**Application by Mallard Pass Solar Farm Limited
for an Order Granting Development Consent
for the Mallard Pass Solar Project
– project ref. EN010127**

Submission by Sue Holloway – unique ID ref. 20036112

Deadline 2: Written Representation

Figure 1 Green Infrastructure Strategy Plan

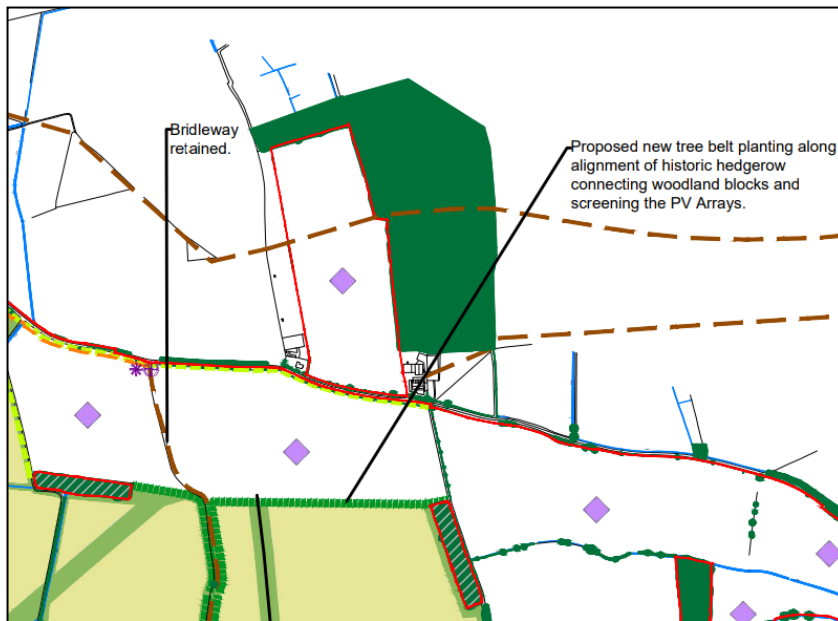
- 5.4.2 However, Figure 1 (figure 6.11 from the Green Infrastructure Strategy Plan (APP-173) as illustrated below) shows new **tree belt planting** not hedgerow as described above.

5.4.3 Planting a tree line is not in keeping with the typical field boundaries and open landscape. The landscape has such far reaching vistas that neither a tree line nor a hedgerow will be effective unless up close to the solar arrays. The lifespan of the development will determine how effective and for how long the 250-300m set-back mitigation will have a screening impact for, especially with respect to tree planting. The lifespan could be as low as 25 years if the technology is superseded, conversely it could be up to 40 years and beyond. Growing a proper thicket hedge would be more appropriate, and if done properly would offer more screening value in the winter months compared to a tree line. It would also replace what used to be a historic hedgerow between those tree belts.

5.5 If this Application were to be approved I would ask that the Applicant sensitively consider the point above and confirm their proposed mitigation. This was raised in my Stage 2 consultation but never received any response from the Applicant.

Figure 2 Construction Access Routes & restrictions (APP-092)

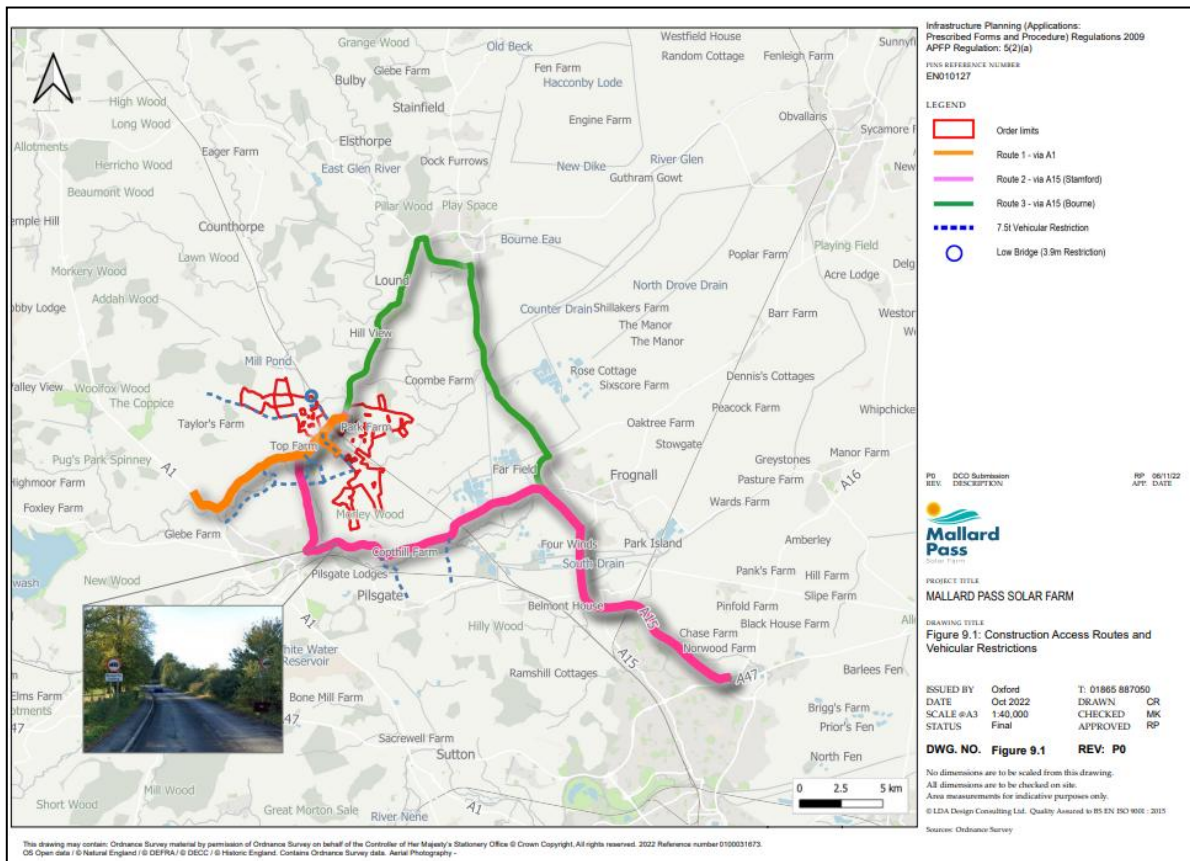
9.1 Just based on the construction period alone the proposed development is not appropriate due to the impacts on local roads and residential areas from the HGV and AIL loads. The 2 routes determined to enter and leave the site via route 1 and 3 respectively are just completely impracticable and will not be adhered to. **The distance and time taken to drive the routes is prohibitive.** Currently with some projects going on locally HGV drivers are breaching their S106 conditions. When stopped in Greatford village by concerned locals and asked why they are travelling this route, they say because they can, there are no weight restrictions and no one is tracking them. The same would be the case for the Applicant's contractors. There is no way to enforce route 1 and 3. You only have to look at the map in Figure 2 below for perspective. The 852Ha site looks tiny outlined in red compared to the proposed routes HGV and LGV drivers will be told to take which are circuitous and impractical.

Figure 3 Traffic Regulation Measures - 5 & 6 (AS-007)

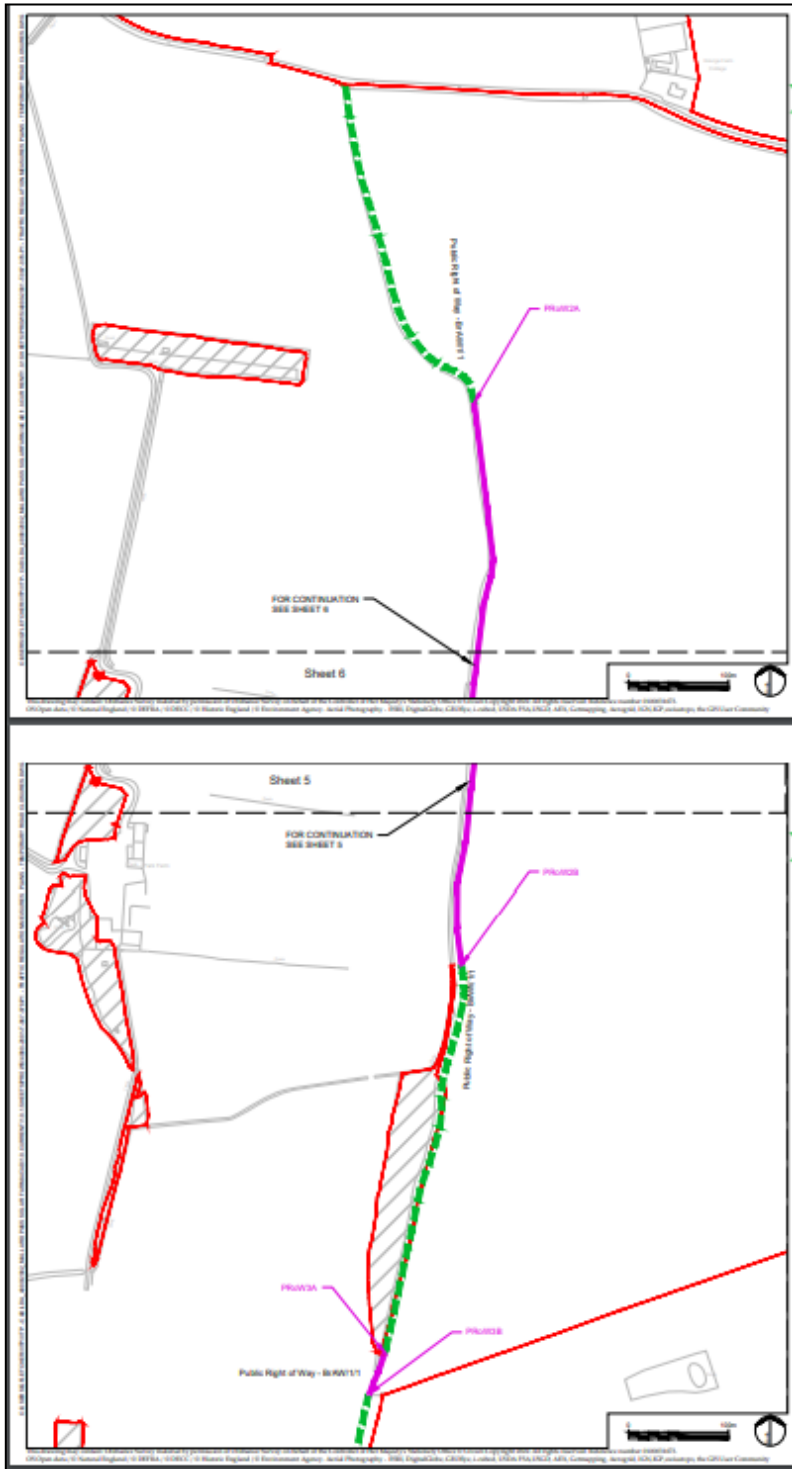
- 10.1.4 Whilst the closure sites at PRoW 2A - 2B and PRoW 3A - 3b are sited mainly opposite to the secondary construction compound, both the closure areas are not on flat land rendering the passage of 80 tonne cranes impractical and potentially dangerous. The land around the tree copse is poorly draining requiring substantial hard core surfaces to be put in place. It is also very close to a watercourse (see Hedgerow Plans below), so the sediment washed off the track could go into the watercourse.

- 10.1.5 Figure 3 PRoW 2A - 2B is an extremely long stretch of closure, there is no explanation why this is necessary.
- 10.1.6 Why are the closures and likely track sited adjacent to the woodland which no doubt has the largest biodiversity habitats? The construction process will cause unnecessary displacement when it could be sited in a flatter more open area.

Figure 4 Hedgerow Plans - sheet 3 (APP-012) PRow2A&B, PRow3A&B

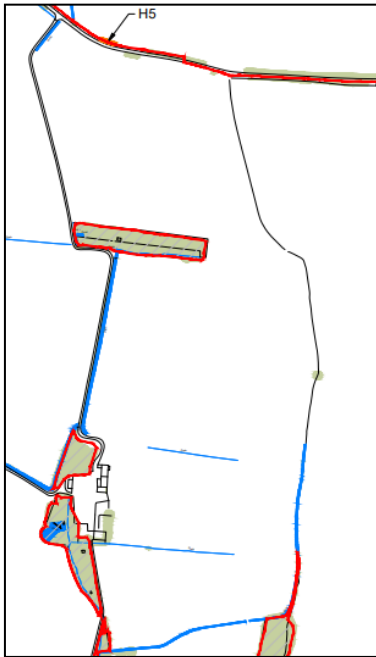
10.2.1 To create a site access on Carlby Road at the NE end of the Order Limits, the Applicant is proposing to move the existing entrance to Park Farm a few metres east to H5. This entrance has received all sorts of agricultural machinery and HGVs over the years without event. Whilst the documents suggest the online swept path analysis has determined the proposed new access is best, from 18 years experience of driving that road every day, the site access will be moved to a more dangerous point on the bend of Carlby Road. The Hedgerow Plans (APP-012) indicates

- 10.2.2 Having reviewed the Hedgerow Plans on Carlby Road, the existing track entrance to Park Farm runs over the top of drainage (see Figure 4). Surely it would be better to maintain the existing track and make sure it is capable of taking the abnormal heavy loads (as it does today), than change the road layout to a more dangerous position on the bend which would require the removal of any trees and hedgerow on the north edge of Carlby Road? The proposed site entrance is dangerous.

Figure 7 Land Plans (APP-005)

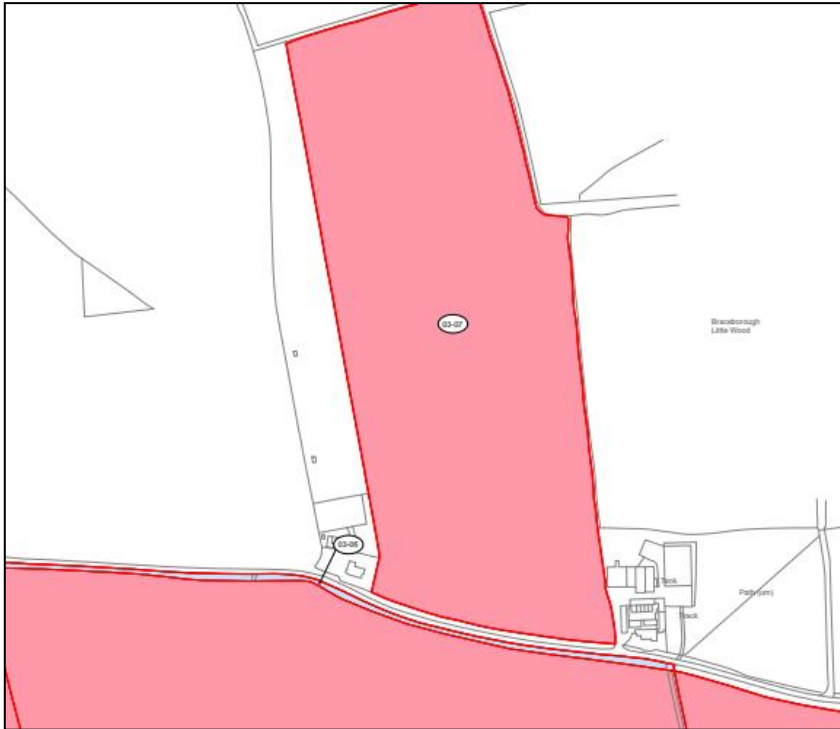
11.2 In respect of plot 03-06 (field 36) why is it necessary to implement compulsory acquisition rights and directly target it at just a section of Carlby Road which already has established hedgerow?

11.3 In respect of plot 03-07 (field 37) which has no visual inter-influence with the solar panels why is it necessary to request CA rights to make green infrastructure changes?

11.4 Whilst the above is just an example there seems to be an over-zealous application of CA rights being requested across the site without due consideration or justification as to why every plot no. request is required.
